PLANNING COMMISSION STAFF REPORT
100 S GARFIELD STREET SUBDIVISION – PRELIMINARY PLAT – SUB322-0001

FILE NO: SUB322-0001

REQUEST: Subdivide a 1.93acre (84,022 sq ft) property into 12 lots for residential homes

**Exhibit C:
Preliminary Plat**

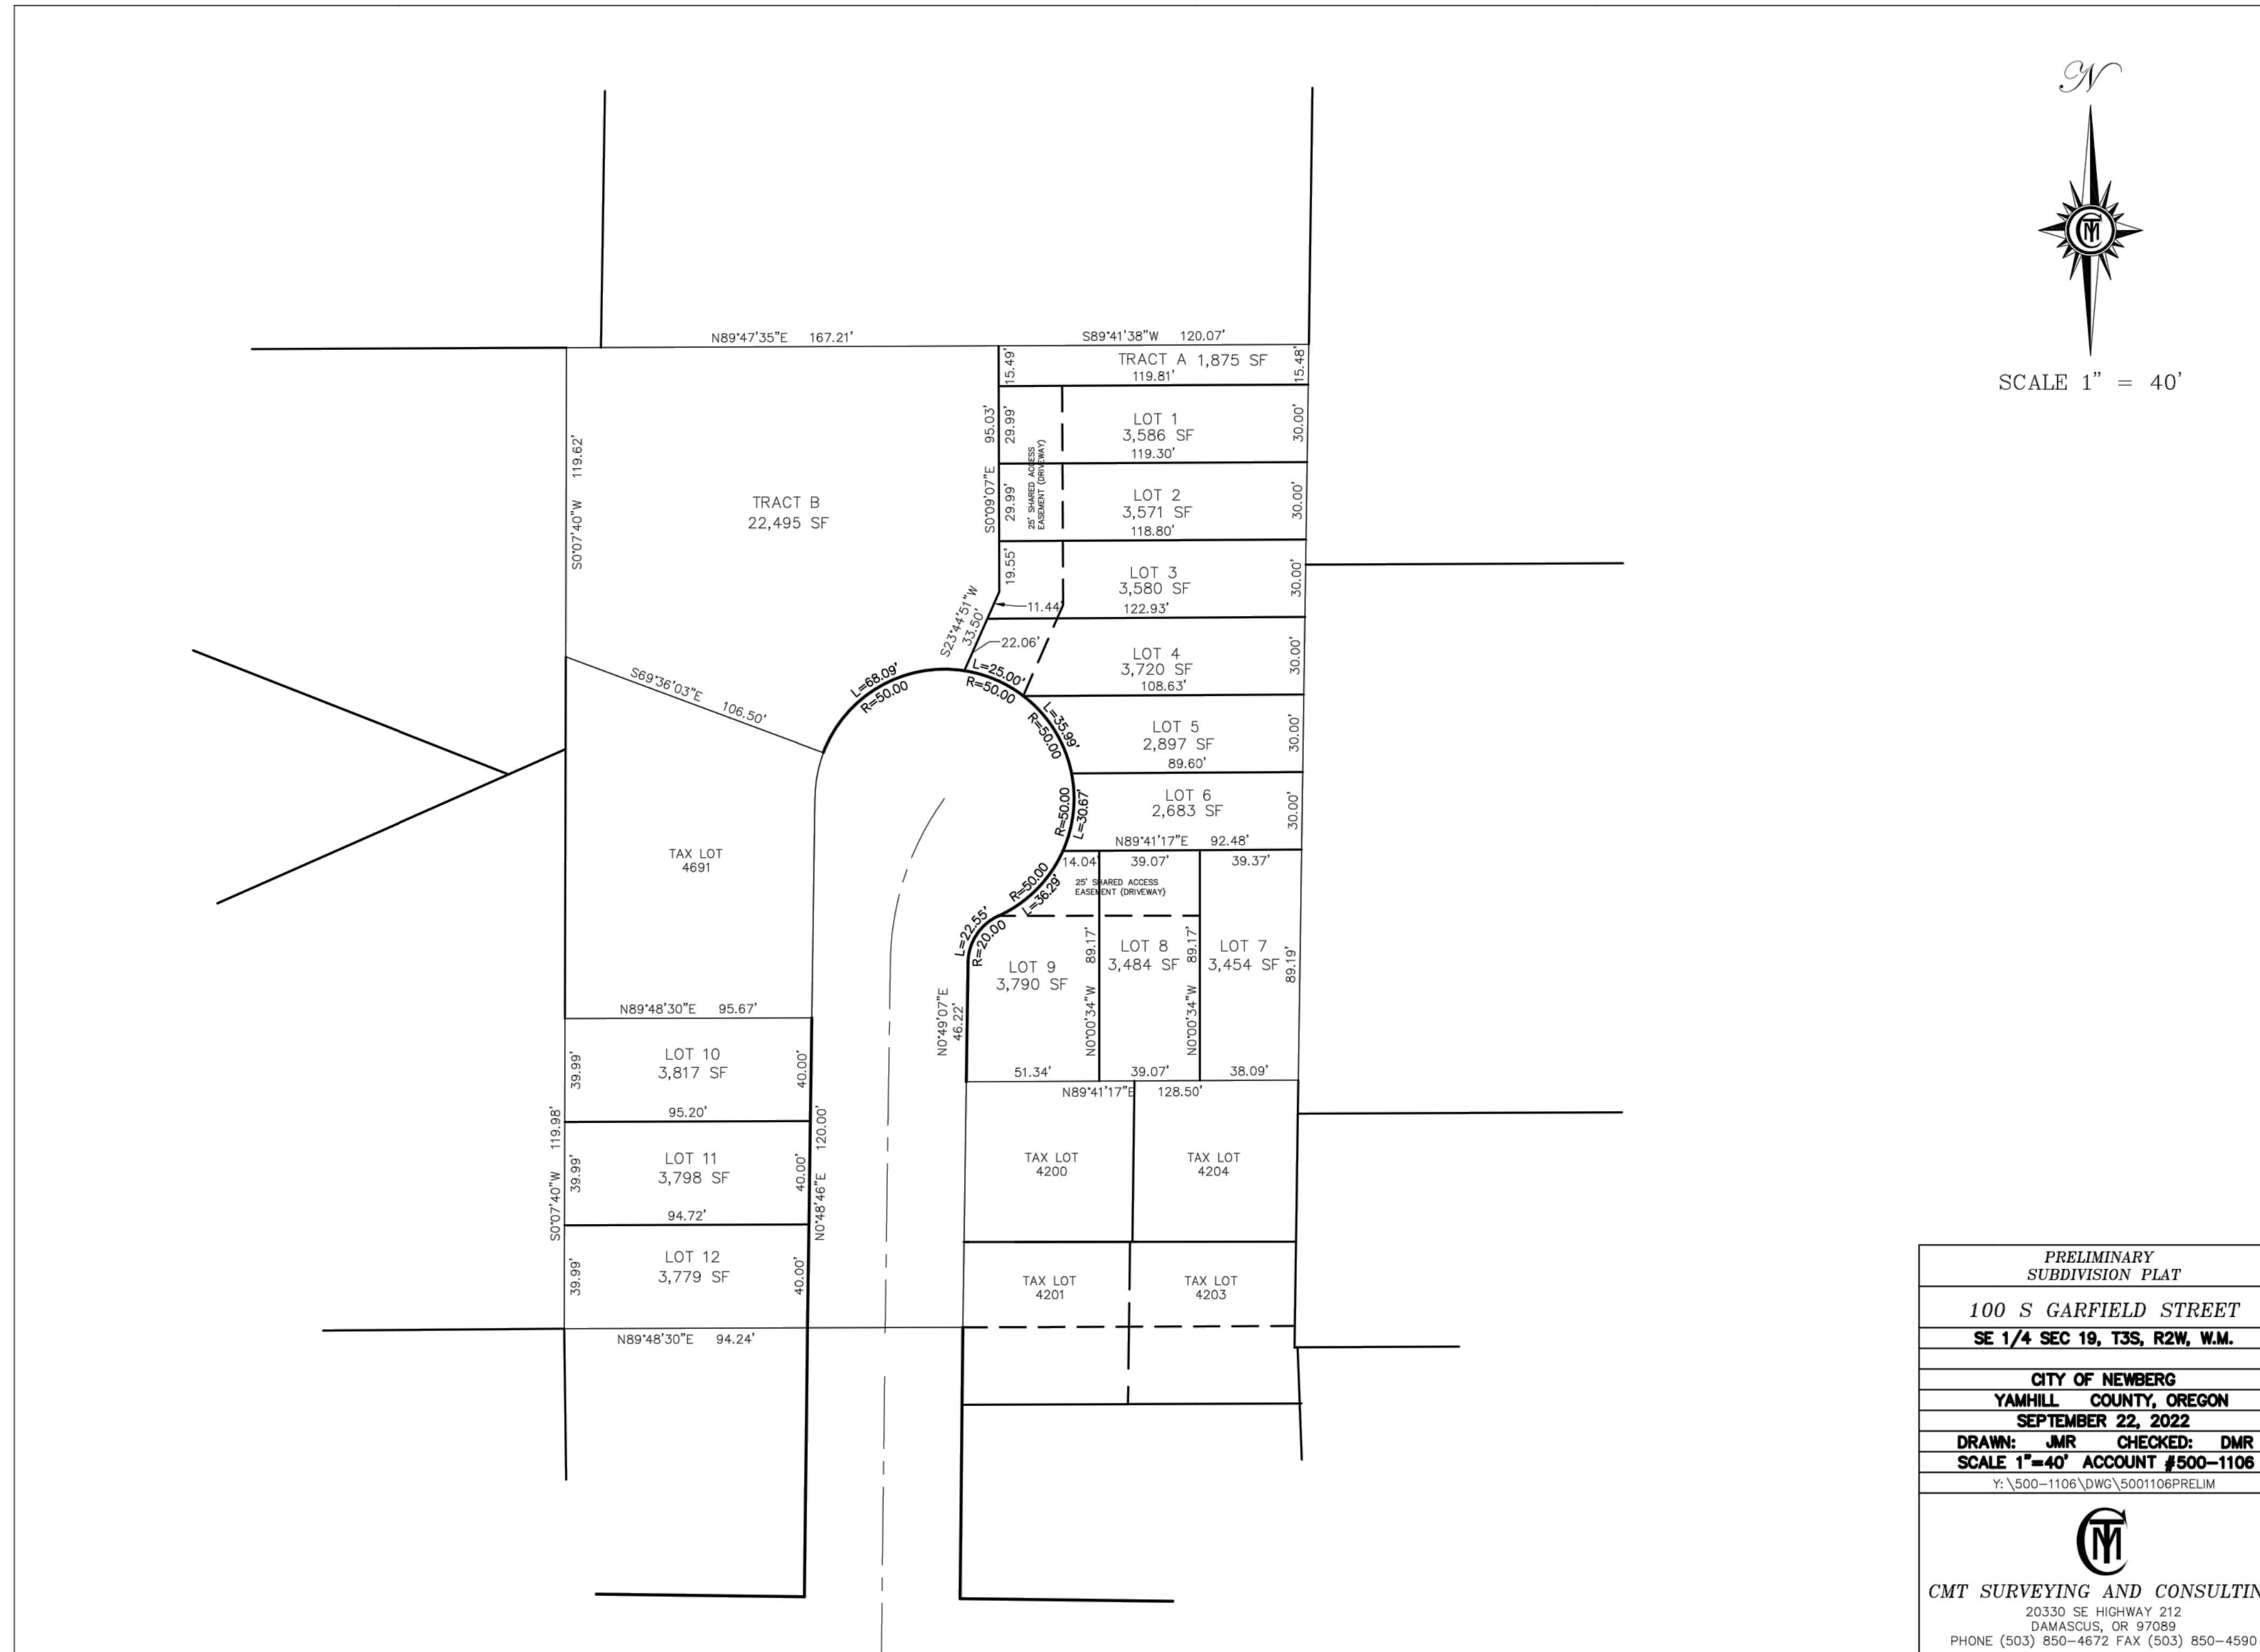
Finding: The proposed preliminary plat shows that the proposed stormwater facility, Tract A, will encroach into the stream corridor overlay area and disturb two separate areas totaling approximately 665 square feet. The stormwater facility will discharge into Tract B, that is located within the stream corridor area. The applicant's narrative does address that this area will be replanted per the included mitigation plan, sheet 6. The proposed stormwater facility is not listed within an approved City of Newberg master infrastructure plan. Therefore, does not qualify as a Type II activity per NMC 15.342.070(D). The installation of a stormwater facility, not within an approved master plan, is most closely related to the activity described in subsection B and therefore, will processed as a Type I procedure. However, due to the requirements of NMC 15.235 that requires proposed subdivisions within a stream corridor to be decided by the Planning Commission, this criterion will also be reviewed by the Planning Commission and not the approved by the director as this section directs.

Finding: The applicant's preliminary plans do not show 10-foot-wide public utility easements along the frontages of all proposed lots along the extension of S Garfield Street. The plans also show shared access and utility easements for Lots 1 through 4 and for Lots 7 through 9. Because the applicant has not submitted construction plans, final plans showing needed utility easements will be required as part of the public works improvement permit application.

PRELIMINARY SITE & UTILITY PLAN
12-LOT SUBDIVISION

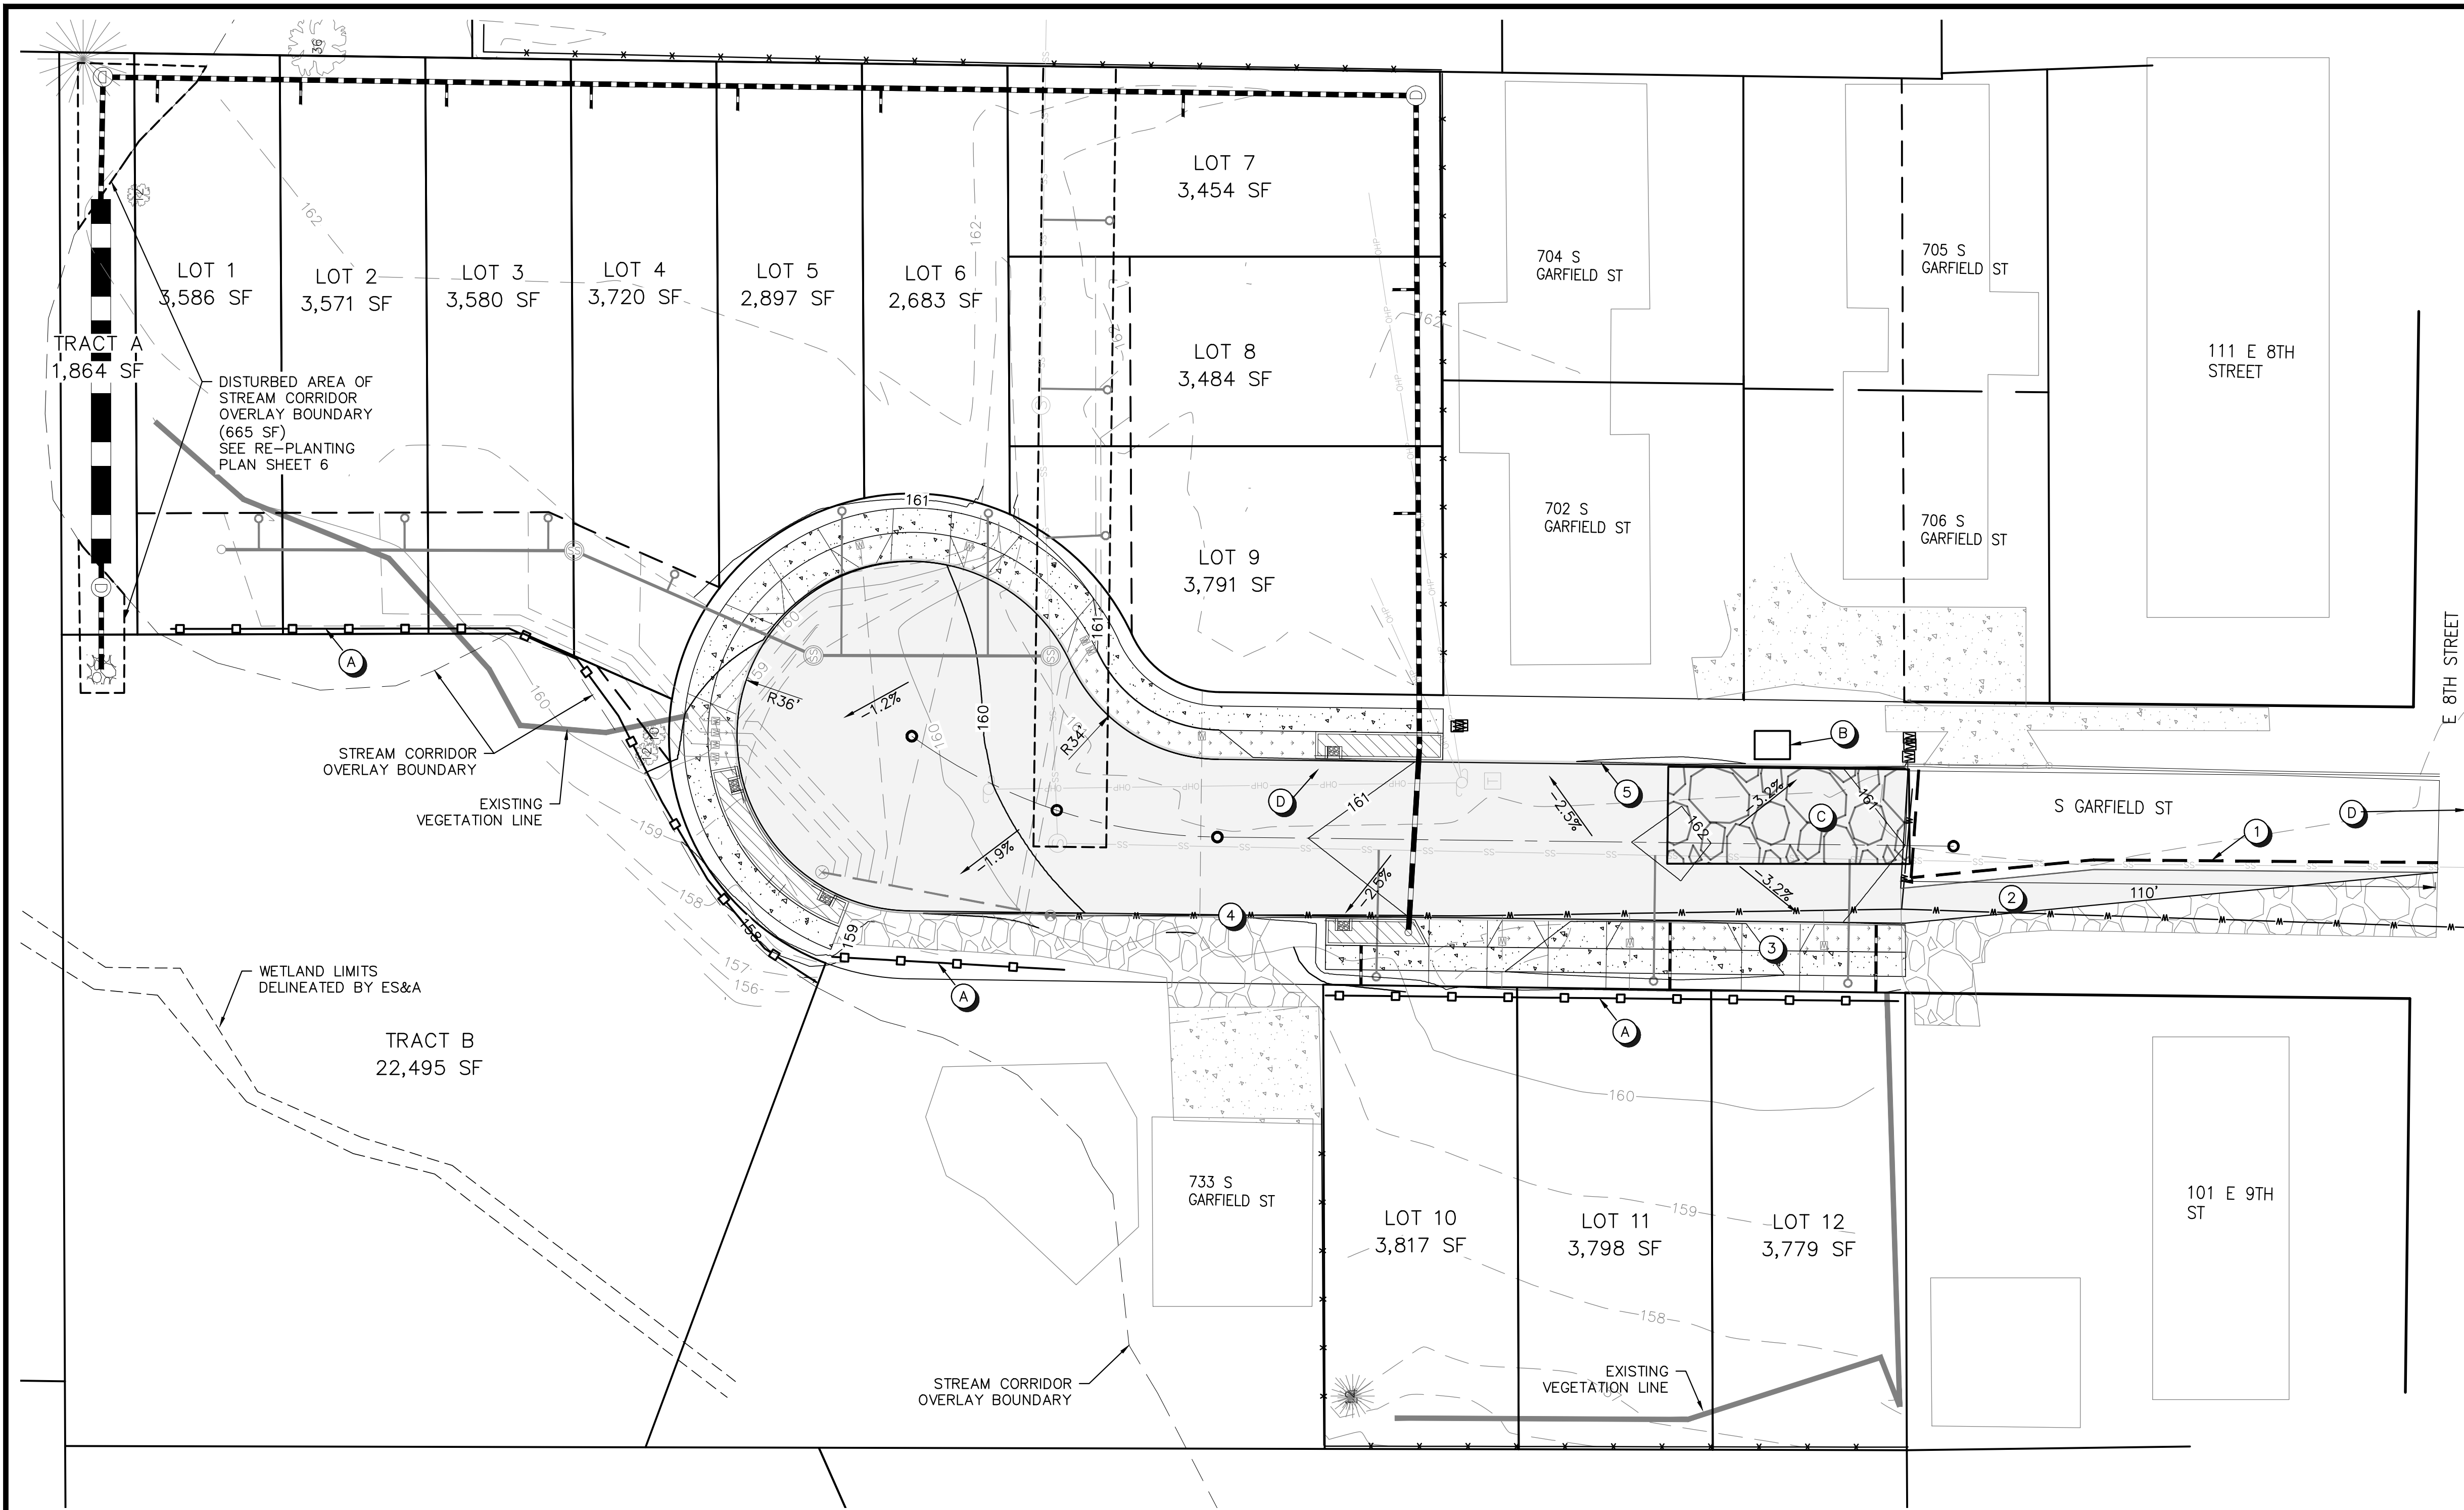
Finding: Preliminary plans show an extension of an existing 4-inch water line in the extension of S Garfield Street. Because the applicant has not submitted construction plans, final water line plans meeting the requirements within the Newberg Public Works Design and Construction Standards will need to be submitted for approval as part of the public improvement permit application. New water mains are to be a minimum of 8-inches in diameter. Public improvements are to be completed prior to applying for the final plat and building permits.

Finding: Preliminary plans show a new wastewater line connecting to an existing wastewater line in S Garfield Street. Preliminary plans also show service laterals to each proposed lot. Because the applicant has not submitted construction plans, final plans for the proposed wastewater line meeting the requirements within the Newberg Public Works Design and Construction Standards will need to be submitted for approval as part of the public improvement permit application. The public main will need to terminate at a manhole within the public street right-of-way. Private service laterals are to be extended to each lot, and to each dwelling if under separate ownership. Private “party” wastewater service lines are not allowed.

through the back side of proposed lots 1 through 9 terminating at a private underground stormwater detention facility in Tract A of the preliminary plat. The outfall of the private stormwater facility is shown within the stream corridor. The applicant proposes to manage both public and private stormwater runoff. Public stormwater runoff from the street is proposed to be managed through stormwater planters. Private stormwater runoff is proposed to be managed by an underground detention system. A preliminary stormwater report prepared by Firwood Design Group was submitted as part of the application. Because a final stormwater management report has not been submitted and final stormwater plans have not been reviewed and approved, a final stormwater management report and construction plans meeting the City's Public Works Design and Construction Standards will be required as part of the public works improvement permit application. The applicant will need to demonstrate compliance with the facility selection hierarchy described in section 4.6.8 of the Public Works Design and Construction Standards.

As shown on the preliminary plans the entire proposed stormwater system would need to be private as public stormwater is to be separated from the management of private stormwater runoff. The responsibility for maintenance of private stormwater facilities or stormwater systems shall be the responsibility of a Homeowner's Association (HOA) or adjacent property owners.
